## **REQUEST FOR COMMITTEE ACTION**

### **HENDERSON COUNTY TECHNICAL REVIEW COMMITTEE**

**SUBJECT:** Revised Master Plan for Cummings Cove, Phase 9 Development Plan, Cummings Cove Villas Development Plan

**Revised Master Plan and (2) Development Plans  
Cummings Cove (2018-M04)**

**CUMMINGS COVE - PHASE 9**

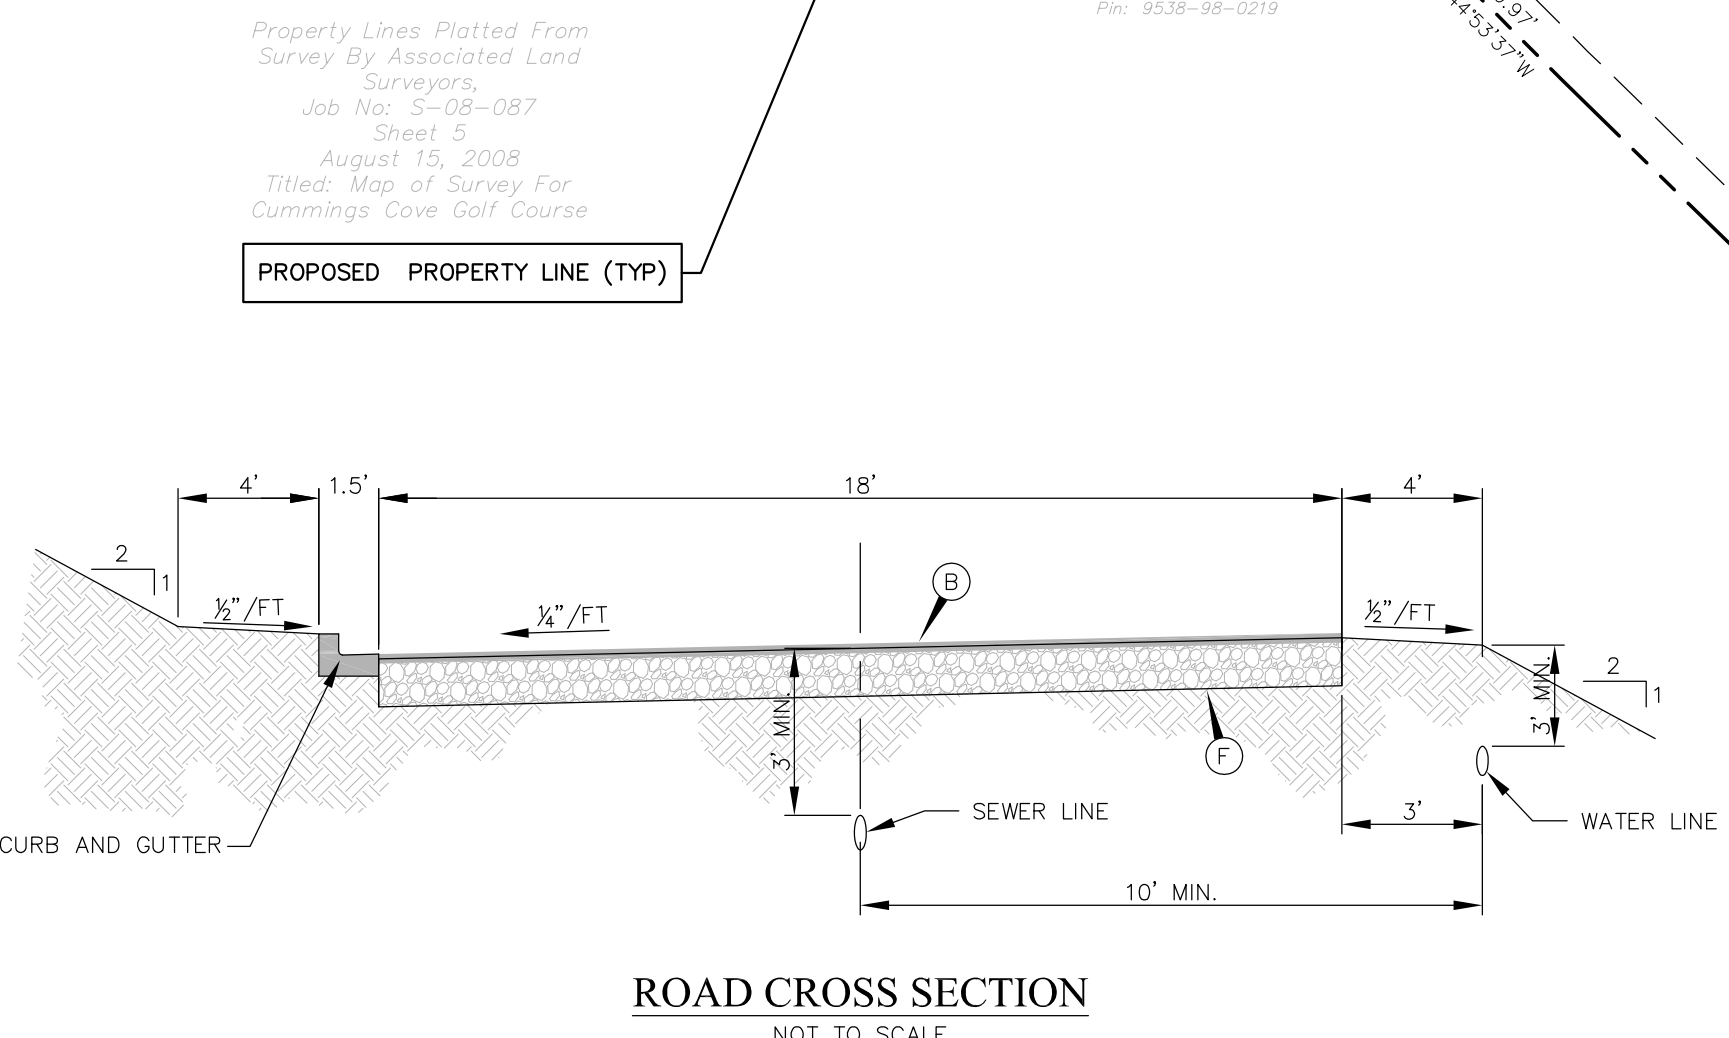
1. **Soil Erosion and Sedimentation Control Plan.** The Applicant shall submit written notice from the appropriate local agencies verifying that an Erosion and Sedimentation Control Plan has been received or a written notice from a professional land surveyor, engineer, landscape architect, architect, or professional planner certifying that no plan is required (LDC §42-113B).

2. **Stormwater Control Plan.** The Applicant shall submit written notice from the appropriate local agencies verifying that a Stormwater Control Plan has been received for the high density option under the Water Supply Watershed requirements for a WS-IV-PA (LDC §42-61).

3. **Private Road Standards.** The Applicant has indicated an addition or reconfiguration for two roads under this development plan. All subdivision roads must be designed and constructed to the minimum standards of LDC §42A-81 C (Table 3.1). The final plat(s) must contain a note stating: *The private roads indicated on this final plat may not meet the requirements of the North Carolina Department of Transportation for acceptance into the state road system.* Planning Staff proposes the following conditions to ensure the private roads meet the standards of the Land Development Code:

- a. **Road Grade.** The maximum road grade for local roads constructed of gravel is 15 percent and 18 percent for asphalt. A professional engineer or professional land surveyor must certify on the Final Plat that no portion of the road has a grade that exceeds the allowable percent or submit a final as-built graded center line profile showing grade and alignment of the road (LDC §42A-81C (Table 3.1). and §42A-81 C(4)).

- b. **Road Drainage and Culverts.** Road or drainage structures shall be constructed in accordance with state roads standards. Road drainage side ditches shall be constructed with

- c. **Road Construction.** A professional engineer or professional land surveyor certify on the final plat that no portion of the constructed roads have grades that exceed maximum allowable grade as defined for each class of road or submit a final as-built graded center line profile showing grade and alignment for all roads (LDC §42A-82).

- d. **Minimum Curve Radius.** Should the Applicant request a reduction in centerline radii, that a professional engineer or professional land surveyor certify on the final plat, the existing cross slope of roadway sections where reductions in centerline radii are requested (LDC §42A-106C).

- e. **Dead Ends, Cul-de-sacs and Turnarounds.** The Applicant proposes one (2) cul-de-sacs or turnarounds located at the end of a local road. All turnarounds must meet of the LDC §42A-105 C(8).

4. **Road Name Approval.** Proposed road names for a private and/or public road shall be preapproved by Henderson County in accordance with Chapter 42 of the Henderson County Code, Property Addressing (LDC §42-98). The applicant lists the proposed road names for most road segments. The names of the shared drives should be confirmed with the development plan approval.

5. **Street Tree Requirements.** According to the street tree requirements of Chapter 42 (LDC §42-145 and LDC §42-146) the applicant must provide one tree per 50 linear feet of property abutting an internal road. Trees may be placed in groups with a minimum spacing of no less than 15 feet and a maximum spacing of no more than 65 feet. The trees may be placed within the right-of-way or within 20 feet of the edge of the right-of-way. The applicant may use existing trees in accordance with LDC §42-153 instead of planting new trees. These existing trees must also be located within the right-of-way or 20 feet off the edge of the right-of-way as required by LDC §42-146

6. **Pedestrian Access.** Sidewalks or walking trails are required for any major subdivision of 10 or more lots outlined in Henderson County Code Chapter 42 (LDC §42-113). Reasonable pedestrian access shall be provided to promote healthy and safe walking when a developer proposes a density equal to or greater than two (2) units per acre. The applicant must provide one (1) linear foot of sidewalk or walking trail for every linear foot of improved or newly proposed roadway within the tract. Sidewalks or walking trails are to be located in a road right-of-way, pedestrian access to easement, or other dedicated open space. Sidewalks are to be constructed at a minimum of 5 feet in width using concrete, asphalt, or other permanent all-weather surface such as gravel.

10. **Public Utilities.** City of Hendersonville water currently serves the project site. Extensions of public water are proposed to serve the project. According to the LDC, the applicant must provide evidence that the water supply plans have been approved by the appropriate agency. The development plan may be approved contingent on final approval from such agency; however, the final plat shall not be approved until all such final approvals have been obtained. Any subdivision served by a public water system shall meet the respective county or municipality's minimum requirements for fire hydrant installation.

11. **Utilities.** Any County approval is contingent upon approval from State for the proposed on site sewer system.
12. **Stream Setbacks.** A minimum thirty-foot setback for buildings or other structures is required along all perennial streams. The thirty-foot setback must be noted on the final plat (LDC §42A-37A).

14. **Fire Protection Requirements.** Any subdivision served by a public water system shall meet the County's standard of one (1) hydrant per 1000 feet of linear road distance. (LDC §42A-81 B(4))

**SITE DEVELOPMENT PLAN**

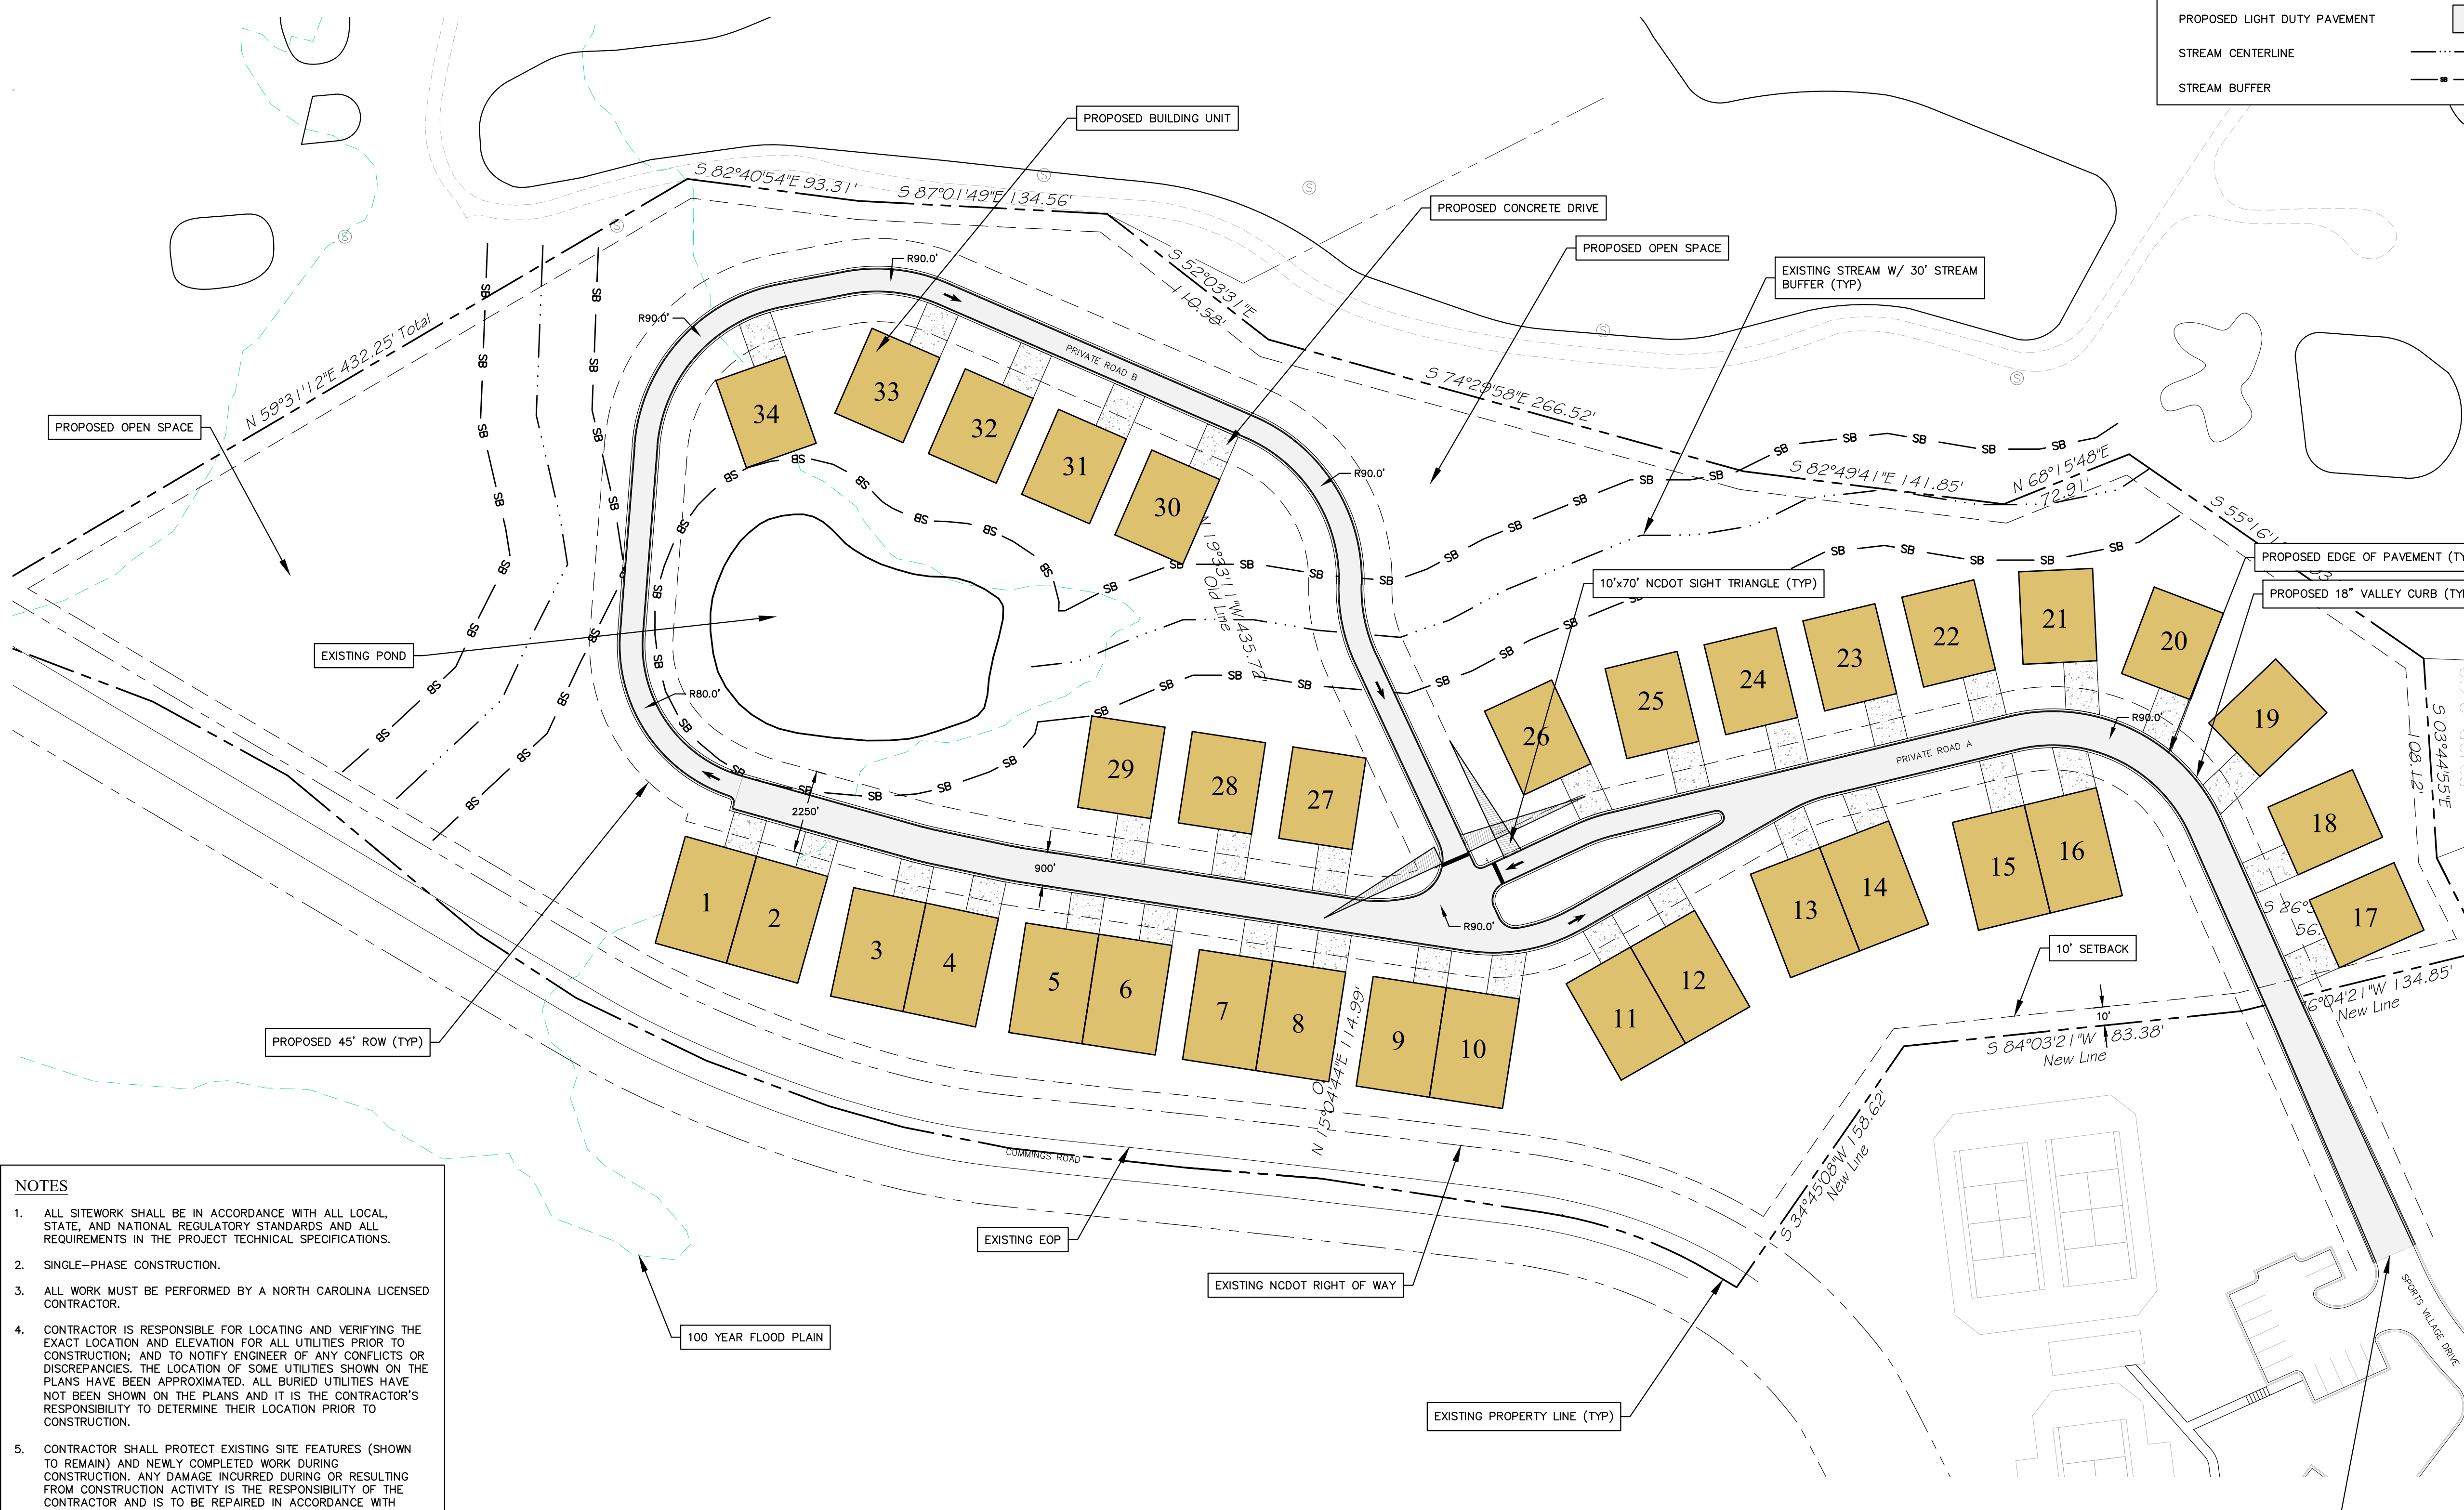
1. **Soil Erosion and Sedimentation Control Plan.** The Applicant shall submit written notice from the appropriate local agencies verifying that an Erosion and Sedimentation Control Plan has been received or a written notice from a professional land surveyor, engineer, landscape architect, architect, or professional planner certifying that no plan is required (LDC §42-113B).

2. **Stormwater Control Plan.** The Applicant shall submit written notice from the appropriate local agencies verifying that a Stormwater Control Plan has been received for the high density option under the Water Supply Watershed requirements for a WS-IV-PA (LDC §42-61).

3. **Private Road Standards.** The Applicant has indicated an addition or reconfiguration for two roads under this development plan. All subdivision roads must be designed and constructed to the minimum standards of LDC §42A-81 C (Table 3.1). The final plat(s) must contain a note stating: *The private roads indicated on this final plat may not meet the requirements of the North Carolina Department of Transportation for acceptance into the state road system.* Planning Staff proposes the following conditions to ensure the private roads meet the standards of the Land Development Code:

- a. **Road Grade.** The maximum road grade for local roads constructed of gravel is 15 percent and 18 percent for asphalt. A professional engineer or professional land surveyor must certify on the Final Plat that no portion of the road has a grade that exceeds the allowable percent or submit a final as-built graded center line profile showing grade and alignment of the road (LDC §42A-81C (Table 3.1). and §42A-81 C(4)).

- b. **Road Drainage and Culverts.** Road or drainage structures shall be constructed in accordance with state roads standards. Road drainage side ditches shall be constructed with sufficient depth and width to carry the expected volume of storm water runoff (LDC §42A-100).

- c. **Road Construction.** A professional engineer or professional land surveyor certify on the final plat that no portion of the constructed roads have grades that exceed maximum allowable grade as defined for each class of road or submit a final as-built graded center line profile showing grade and alignment for all roads (LDC §42A-82).

- d. **Minimum Curve Radius.** Should the Applicant request a reduction in centerline radii, that a professional engineer or professional land surveyor certify on the final plat, the existing cross slope of roadway sections where reductions in centerline radii are requested (LDC §42A-106C).

- e. **Dead Ends, Cul-de-sacs and Turnarounds.** The Applicant proposes one (2) cul-de-sacs or turnarounds located at the end of a local road. All turnarounds must meet of the LDC §42A-105 C(8).

4. **Road Name Approval.** Proposed road names for a private and/or public road shall be preapproved by Henderson County in accordance with Chapter 42 of the Henderson County Code, Property Addressing (LDC §42-98). The applicant lists the proposed road names for most road segments. The names of the shared drives should be confirmed with the development plan approval.

5. **Street Tree Requirements.** According to the street tree requirements of Chapter 42 (LDC §42-145 and LDC §42-146) the applicant must provide one tree per 50 linear feet of property abutting an internal road. Trees may be placed in groups with a minimum spacing of no less than 15 feet and a maximum spacing of no more than 65 feet. The trees may be placed within the right-of-way or within 20 feet of the edge of the right-of-way. The applicant may use existing trees in accordance with LDC §42-153 instead of planting new trees. These existing trees must also be located within the right-of-way or 20 feet off the edge of the right-of-way as required by LDC §42-146

6. **Pedestrian Access.** Sidewalks or walking trails are required for any major subdivision of 10 or more lots outlined in Henderson County Code Chapter 42 (LDC §42-113). Reasonable pedestrian access shall be provided to promote healthy and safe walking when a developer proposes a density equal to or greater than two (2) units per acre. The applicant must provide one (1) linear foot of sidewalk or walking trail for every linear foot of improved or newly proposed roadway within the tract. Sidewalks or walking trails are to be located in a road right-of-way, pedestrian access to easement, or other dedicated open space. Sidewalks are to be constructed at a minimum of 5 feet in width using concrete, asphalt, or other permanent all-weather surface such as gravel.

10. **Public Utilities.** City of Hendersonville water currently serves the project site. Extensions of public water are proposed to serve the project. According to the LDC, the applicant must provide evidence that the water supply plans have been approved by the appropriate agency. The development plan may be approved contingent on final approval from such agency; however, the final plat shall not be approved until all such final approvals have been obtained. Any subdivision served by a public water system shall meet the respective county or municipality's minimum requirements for fire hydrant installation.

11. **Utilities.** Any County approval is contingent upon approval from State for the proposed on site sewer system.
12. **Stream Setbacks.** A minimum thirty-foot setback for buildings or other structures is required along all perennial streams. The thirty-foot setback must be noted on the final plat (LDC §42A-37A).

14. **Fire Protection Requirements.** Any subdivision served by a public water system shall meet the County's standard of one (1) hydrant per 1000 feet of linear road distance. (LDC §42A-81 B(4))
